Addendum No. ADD-01
Date: June 13, 2022
Project: City of Great Falls
Human Resource Department Tenant Improvement
Architect: Cushing Terrell
219 2nd Avenue South
Great Fall, Montana 59405
To: All Plan Holders of Record
Pages: 7 TOTAL – (3) 8 ½ x 11 and (4) 24 x 36 (If you did not receive correct # of pages, please notify us immediately)

Acknowledge receipt of this Addendum by inserting its number and date in the Proposal Form. Failure to do so may subject Bidder to disqualification. This Addendum forms a part of the Contract Documents. It modifies them as follows:

SHEET A012

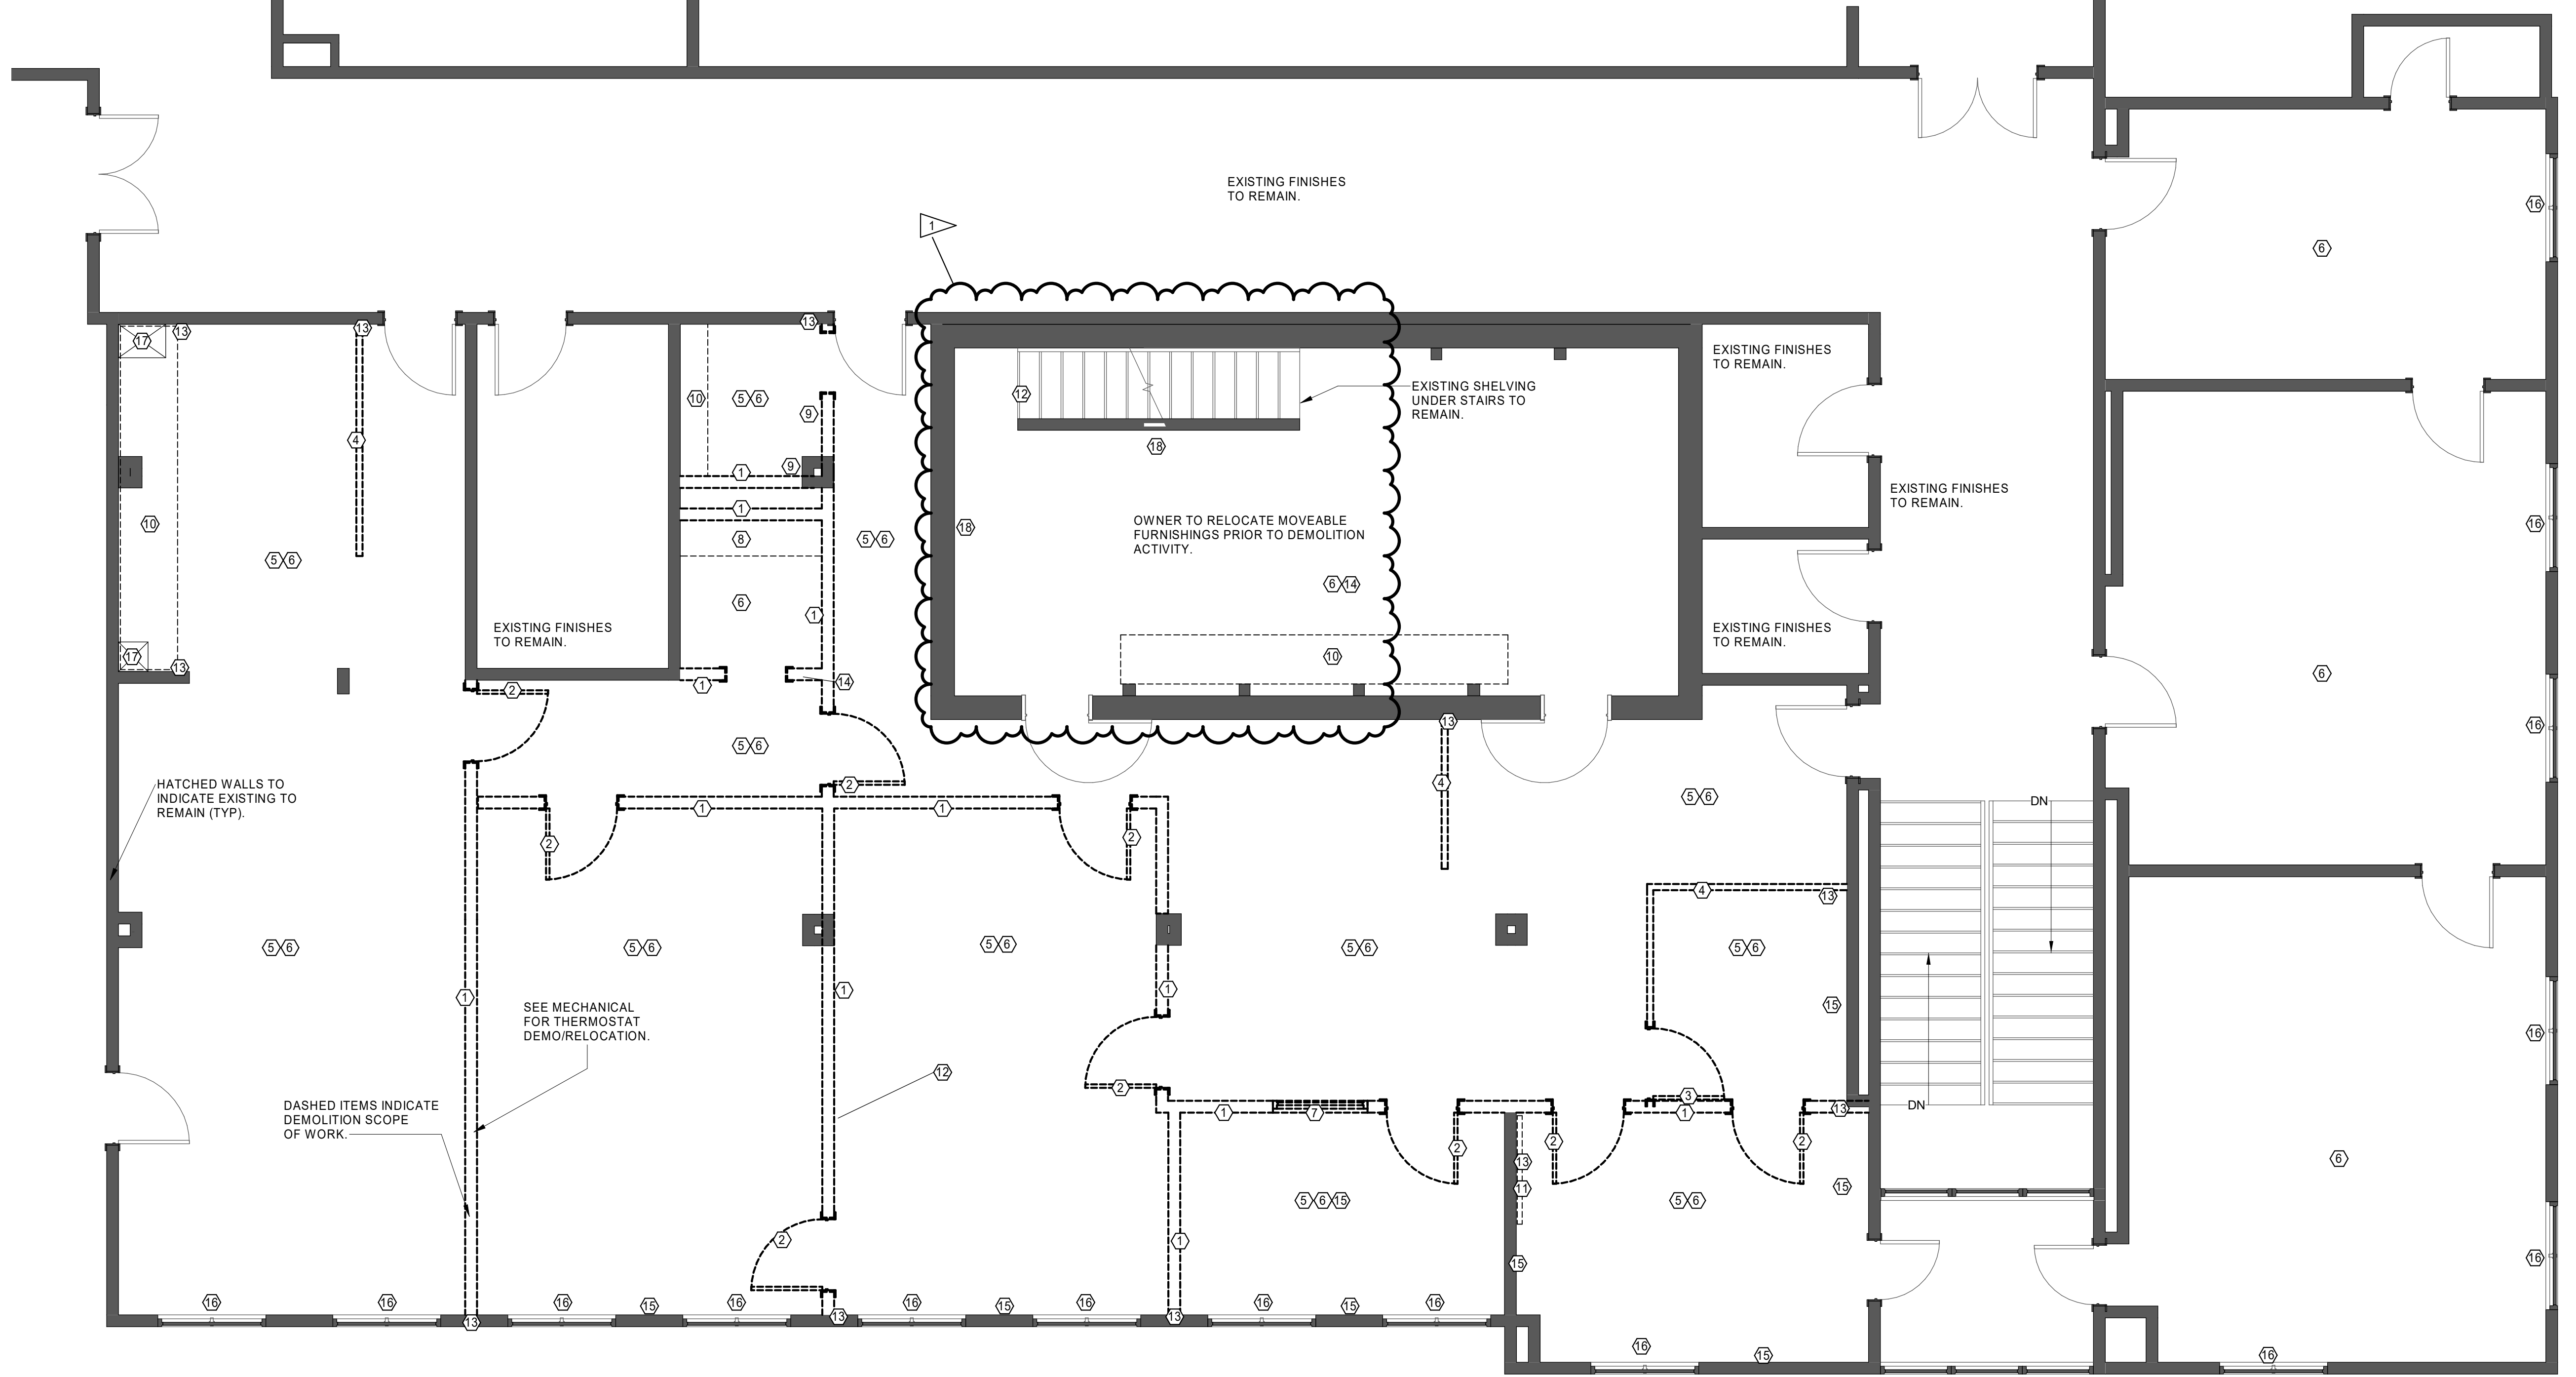
1. ADD: Added keynote 18 to indicate any files or file cabinets that cannot be moved during construction need to be covered/protected from construction debris and dust.

- b. Drawings indicate this now – keynote 18.
11. Question: Electrical plan calls for new circuit for IT Room City 190. Can the existing panel in that room be used instead of a new line across hall?

1 SECOND FLOOR - RENO - FINISH PLAN

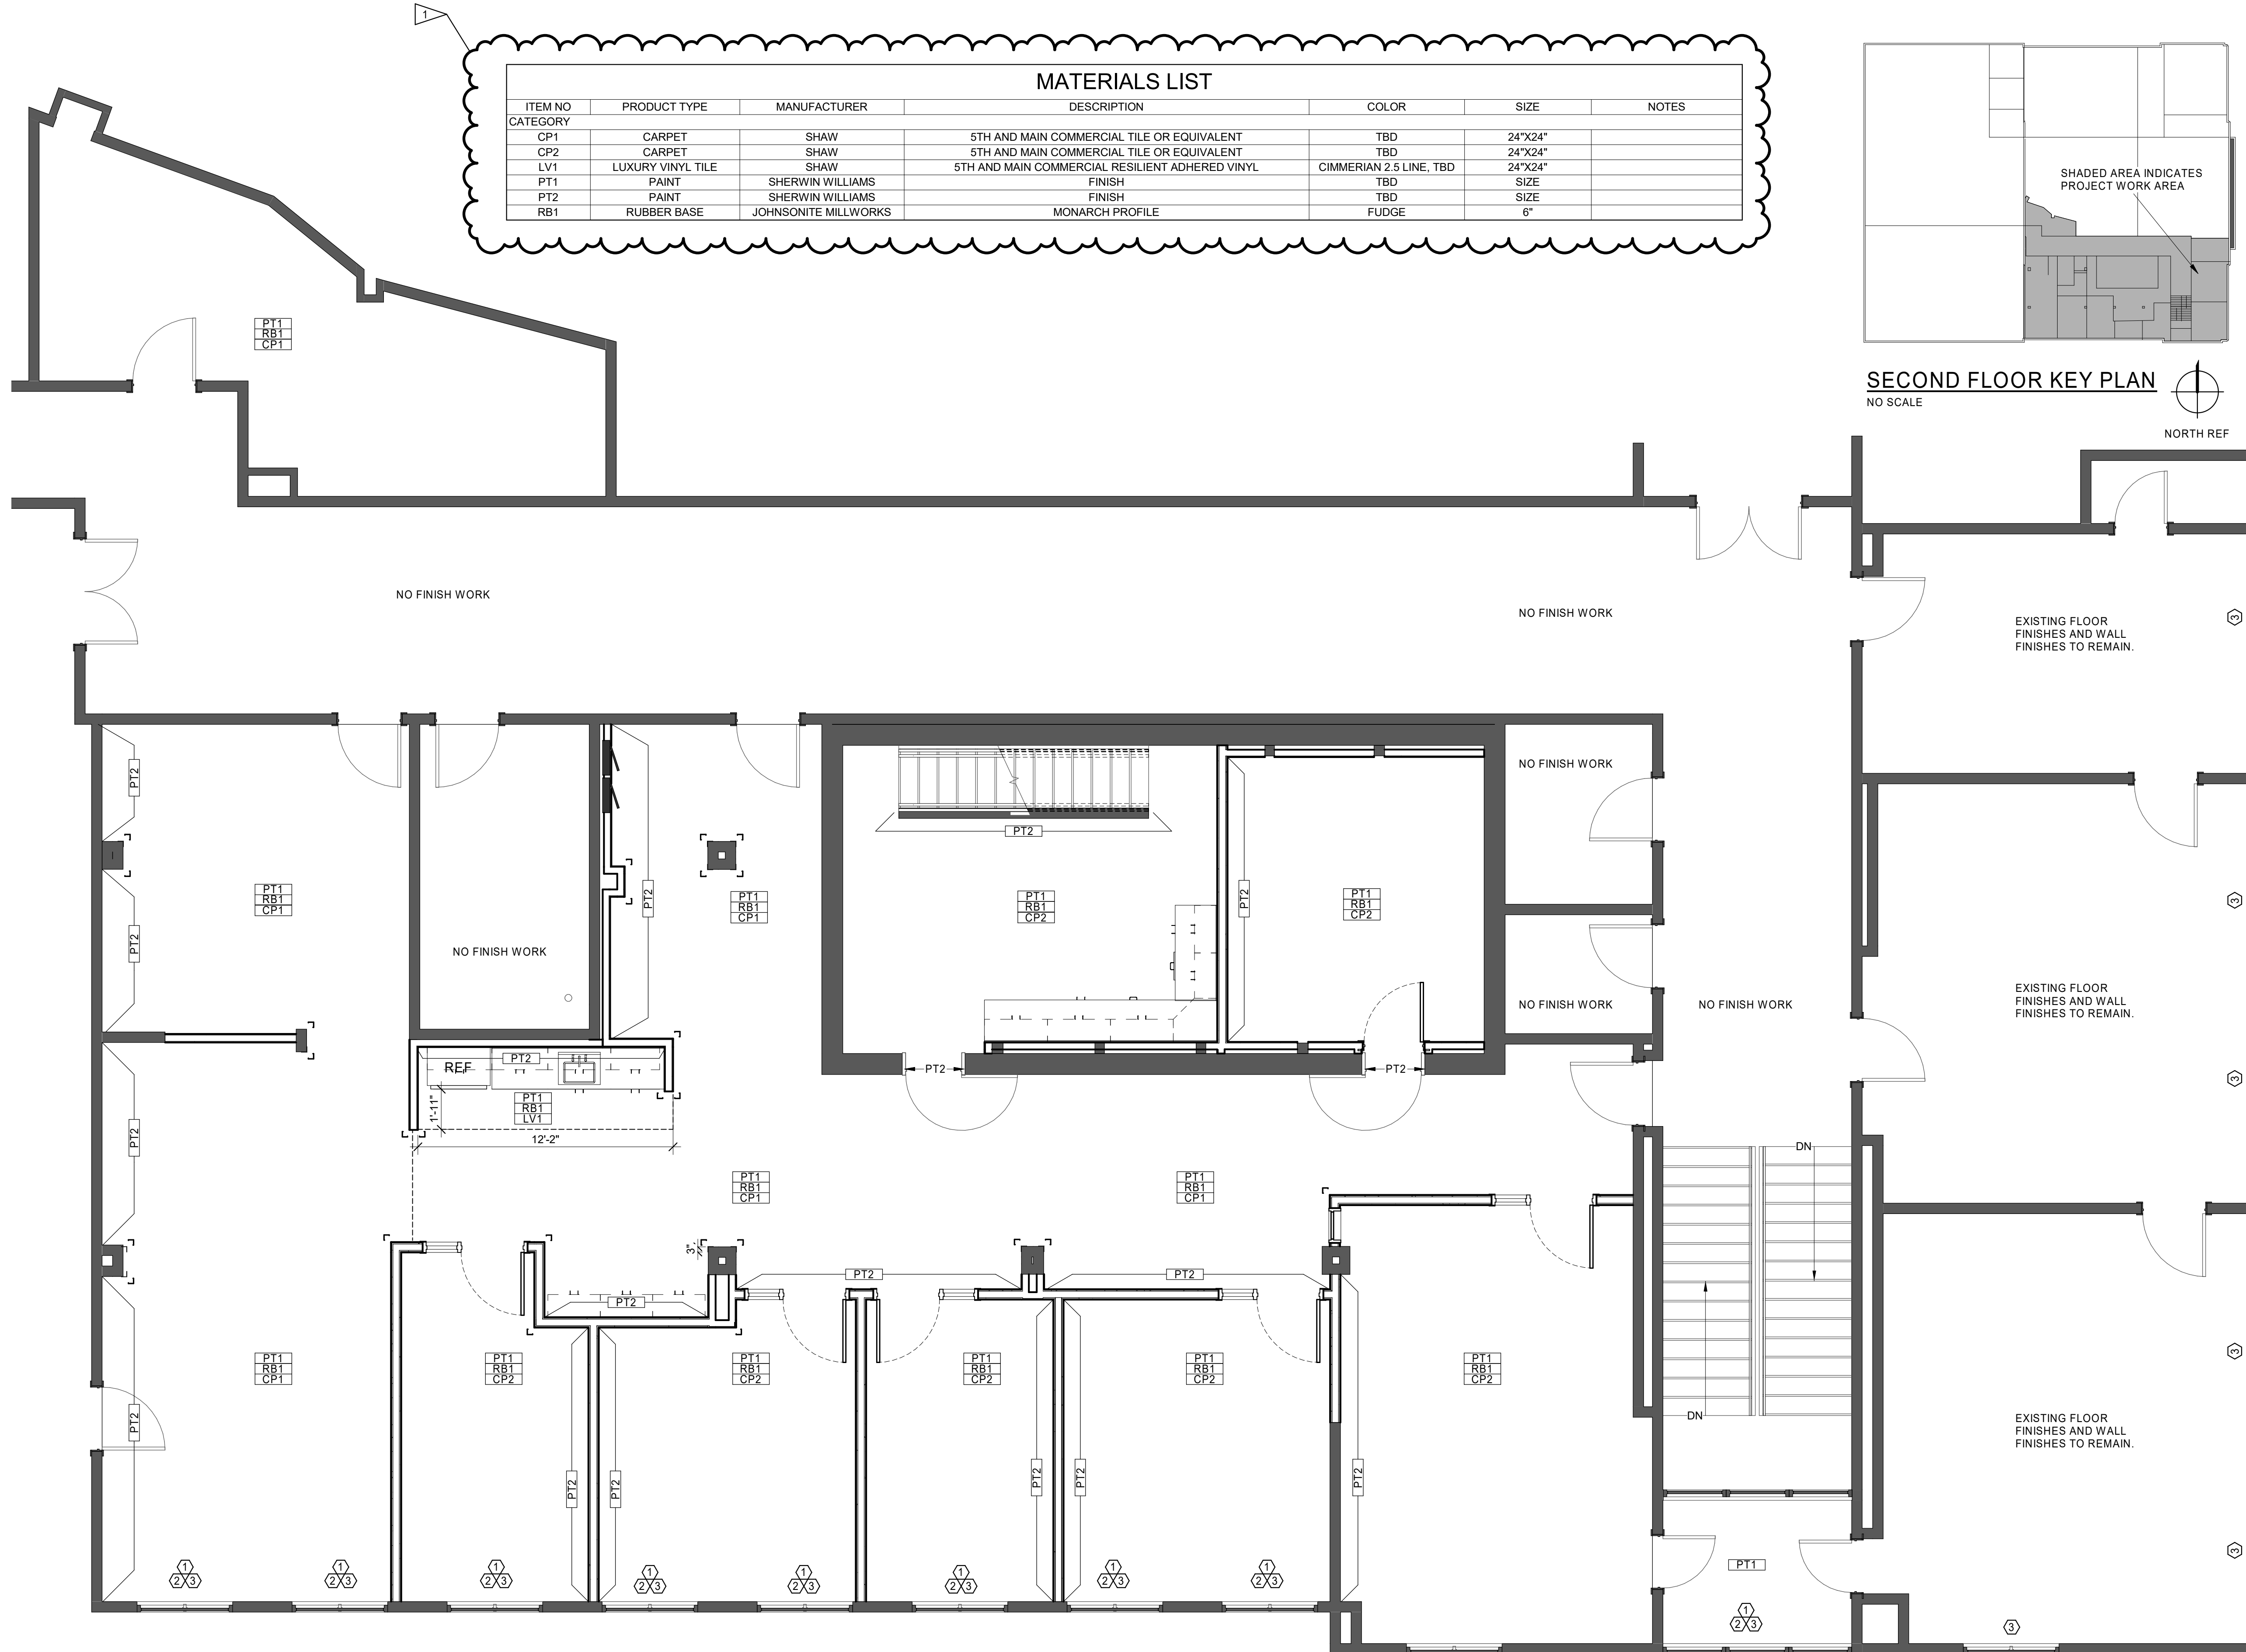
1. MODIFY: Finish schedule modified to indicate correct materials and colors to be determined.

1. **Bid Date has been changed to June 21, 4:00 pm local time.**
2. Question: Millwork Monarch does not come in 4". It is a 6" base. Please clarify.
 - a. Answer: Change to 6" base. Mandalay. Mitered corners.

- b. Drawings have been updated accordingly.
3. Question: CPT1 calls out Rewoven Honed Tile Element. This does not exist. Please clarify.
 - a. Answer: CPT1 is corrected to: Shaw Commercial 24"x24" Rewoven Collection in Trace - Color : Clay.

- b. Finish material have been updated accordingly.
4. Question: CPT2 Rewoven Traced Tile Element. This does not exist. Please clarify.
 - a. Answer CPT2 is corrected to: Shaw Commercial 24"x24" Rewoven Collection in Trace - Color : Zinc.

1 SECOND FLOOR - RENO LIGHTING PLAN
E201 1/4" = 1'-0"

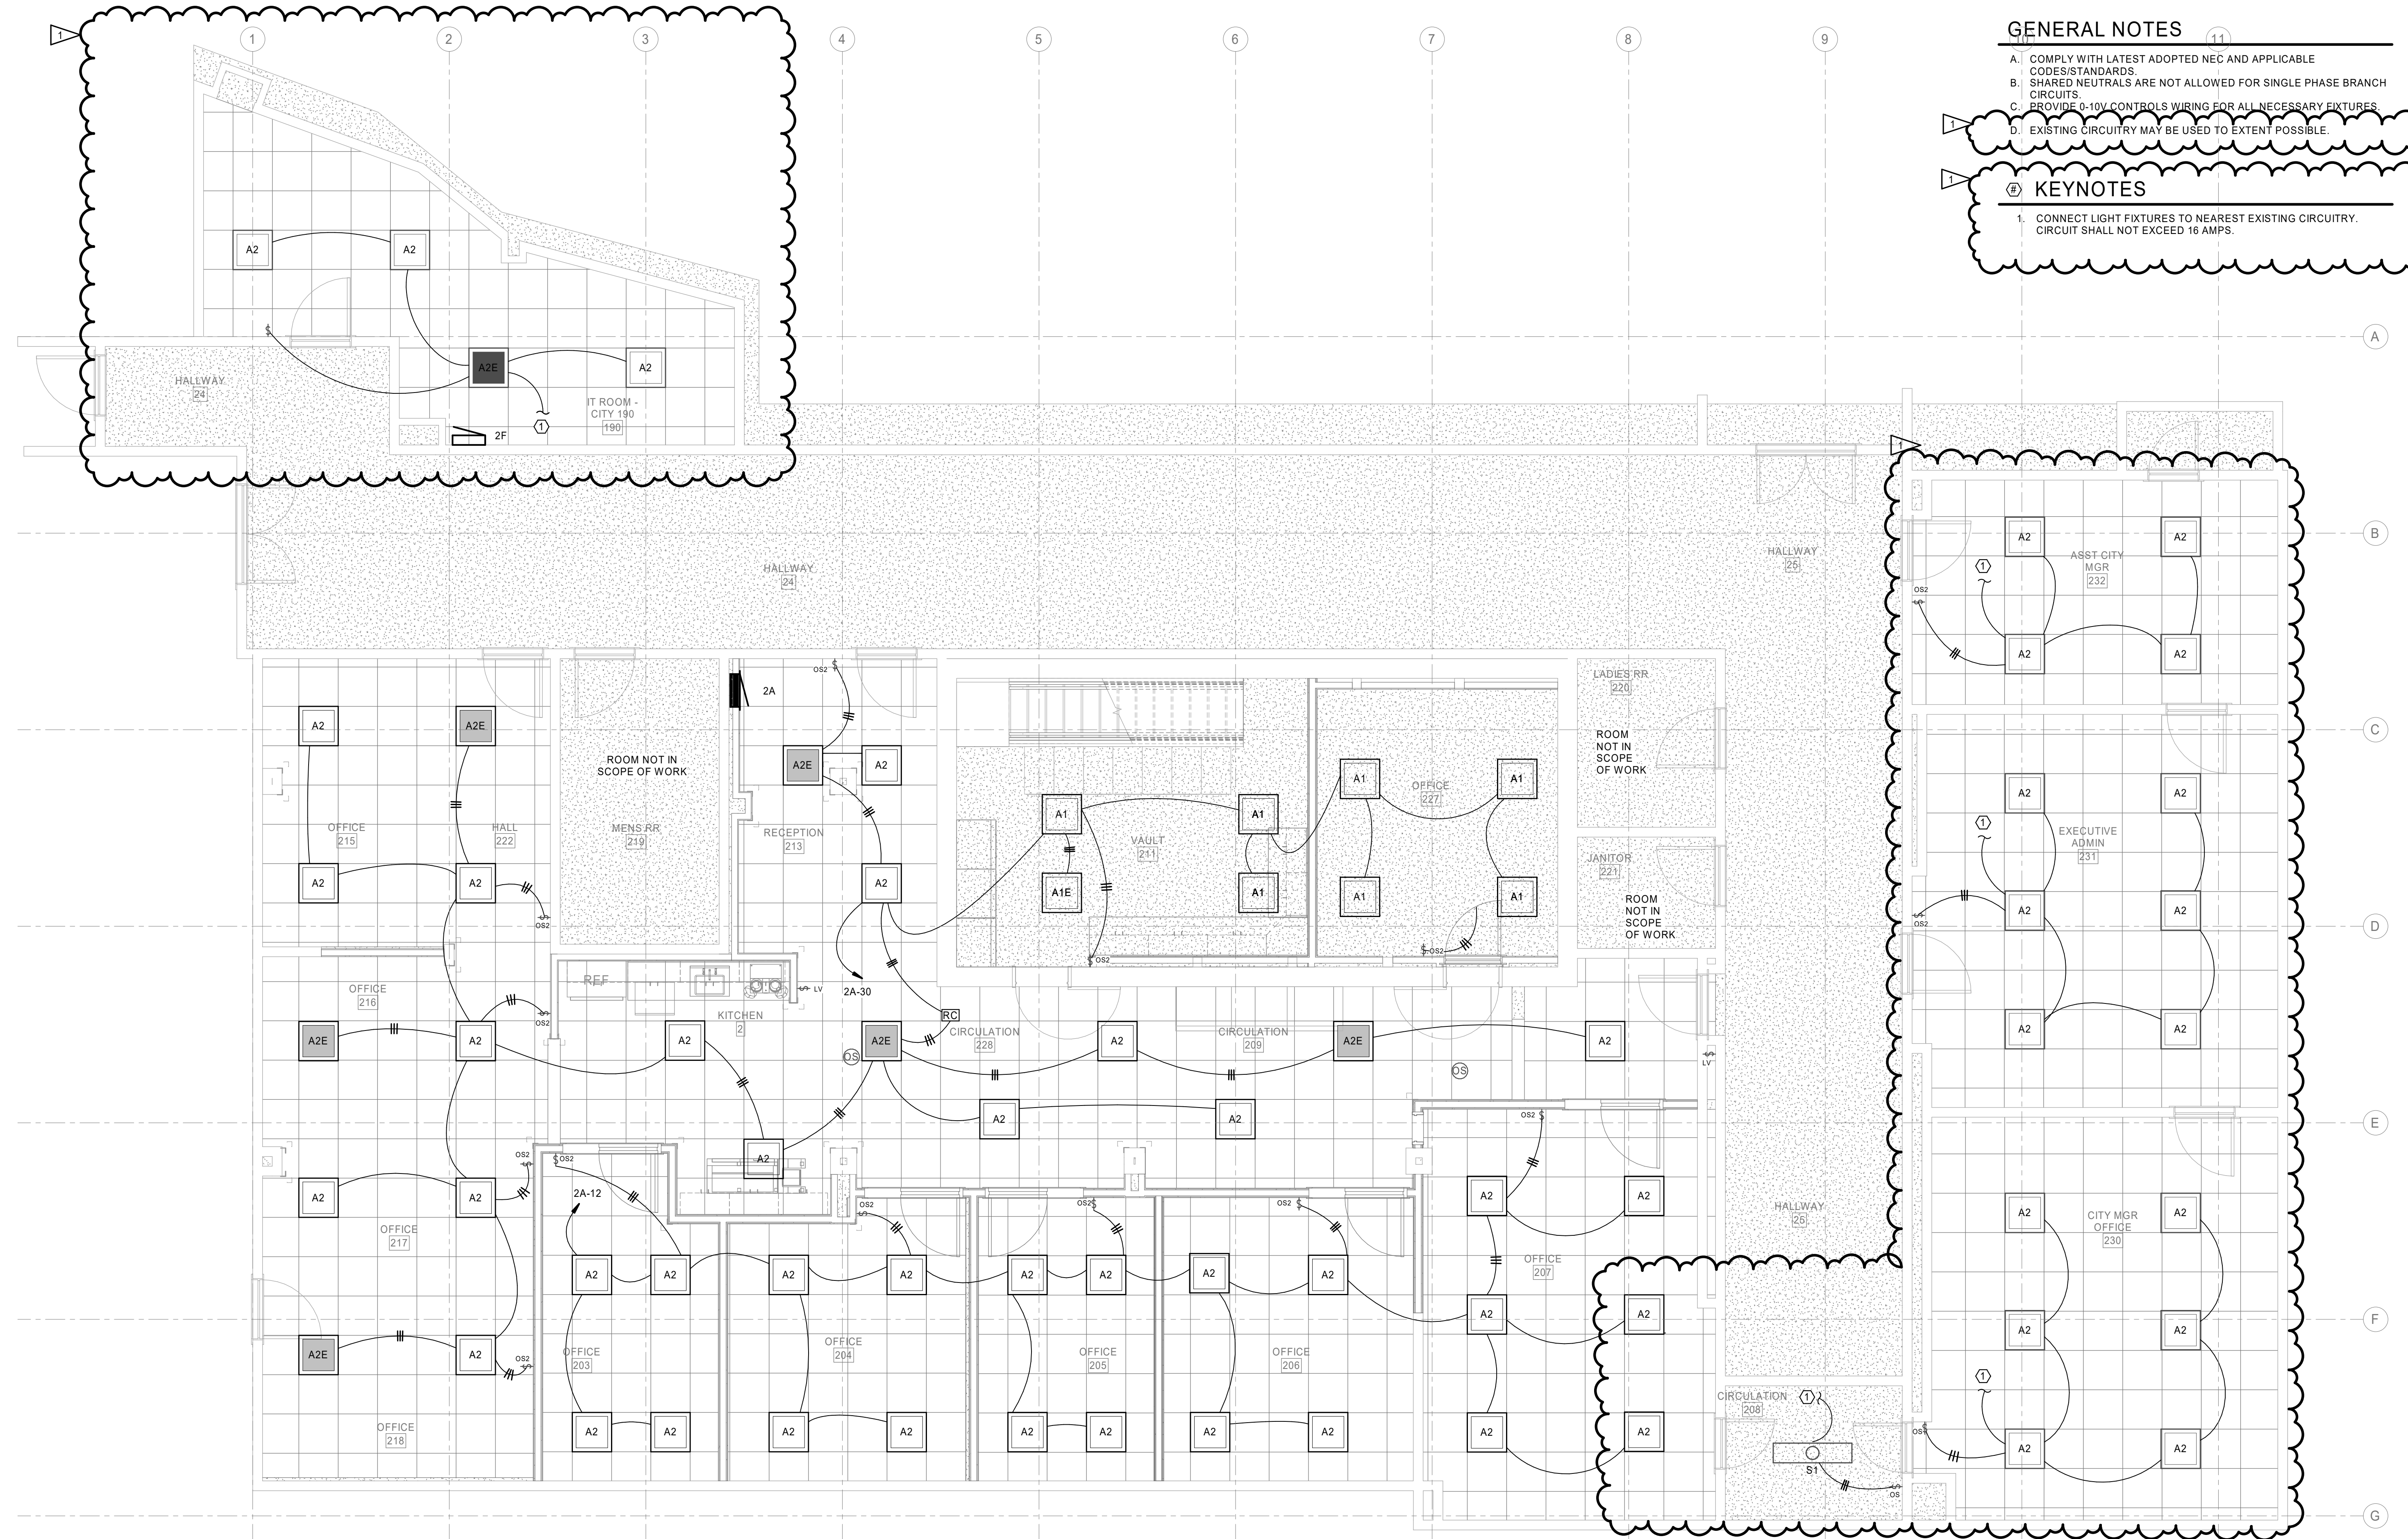
1. MODIFY: Lighting circuitry to allow use of existing circuitry, avoid crossing hallways with new circuitry.
2. MODIFY: General notes to allow use of existing circuitry.
3. MODIFY: Keynotes to include keynote 1 to allow use of existing circuitry.

- 1. CONNECT LIGHT FIXTURES TO NEAREST EXISTING CIRCUITRY. CIRCUIT SHALL NOT EXCEED 16 AMPS.
